INTERNAL MEMORANDUM
Highways, Transport and Design

Proposal: Application for the erection of food store with associated car parking and landscaping.	Date:	06/03/19		
Location: Land North Of Blair Avenue, Ingleby Barwick	Ref:	18/2403/FUL	REV	3

Executive Summary

Figure 2 - Proposed Store Access

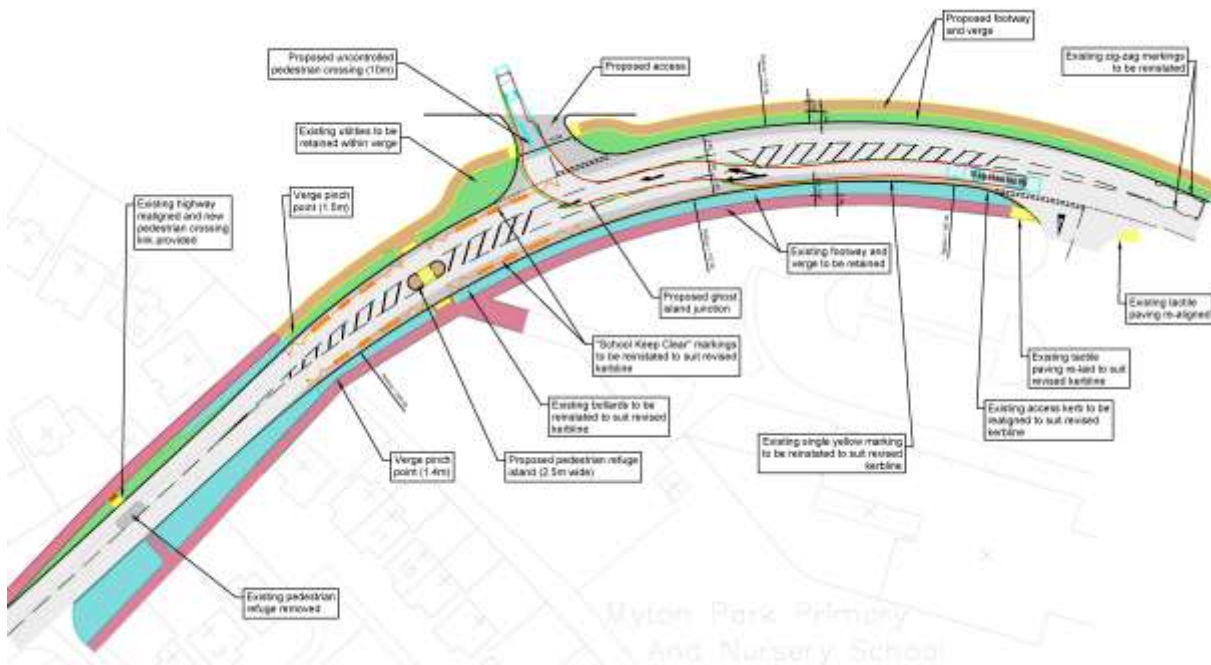
It is proposed to access the site from Blair Avenue via a new ghost island right turn as shown on drawing 251011-ARP-22-XX-DR-CH-0001 (extract included in Figure 2 below).

The proposed site access arrangements have been subject to a Stage 1 Road Safety Audit (RSA), which has also been submitted in support of the proposed application, which has not raised any significant issues.

It is therefore considered, subject to agreement of a servicing plan that the site access arrangements, as shown on drawing 251011-ARP-22-XX-DR-CH-0001, are acceptable.

The works associated with the site access arrangements will be secured via a s278 agreement and will be subject to further detailed design.

Figure 4 – Proposed Footway Connection

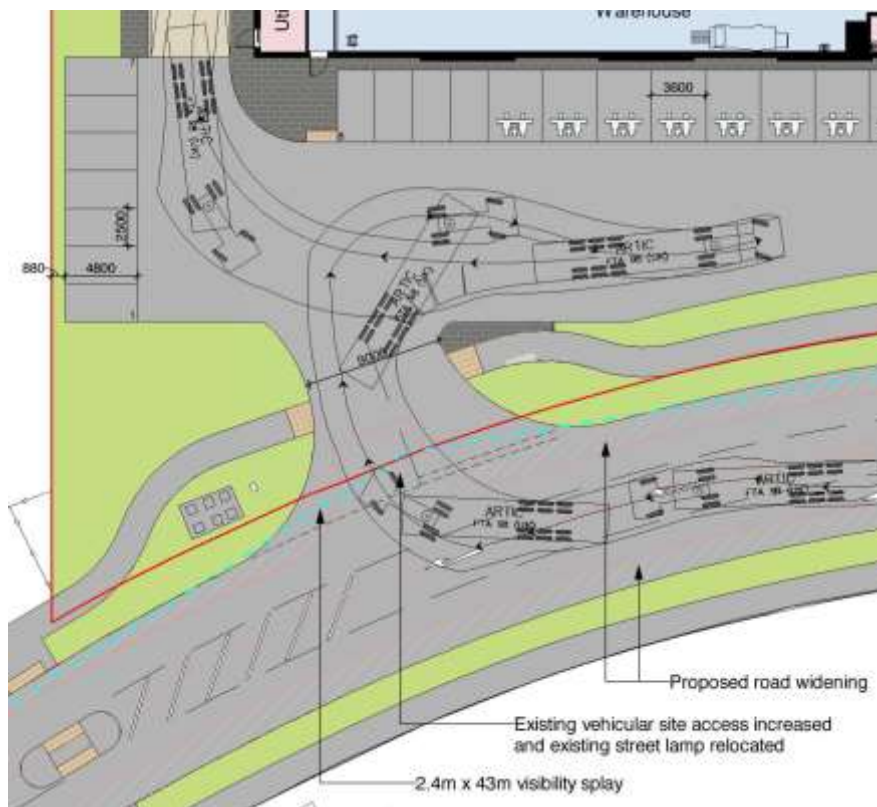
The RSA was not required to address any internal safety issues associated with the layout of the stores car park or pedestrian circulation within this shared space. The applicant is satisfied that all pedestrians accessing the store including those using the vehicular access will be able to do so in a safe way, *“stating that the number of pedestrians arriving from the west that would be minded to cut across this access amount would be negligible”*. The applicant also considered that in putting the footpath in along the length of the car park that they will actively be encouraging pedestrians do cross here and that would result in a greater interaction with cars, they see this to be a greater highways safety issue.

Notwithstanding this assurance the Highways, Transport and Design Manager would recommend the connection of the adopted footway to the car park to avoid an obvious desire line being created though the proposed soft landscaping. See Figure 4 below.

The Highways, Transport and Design Manager also notes that any footpath along the length of the car park would result in the loss of essential landscaping leading to a Landscape and Visual objection.
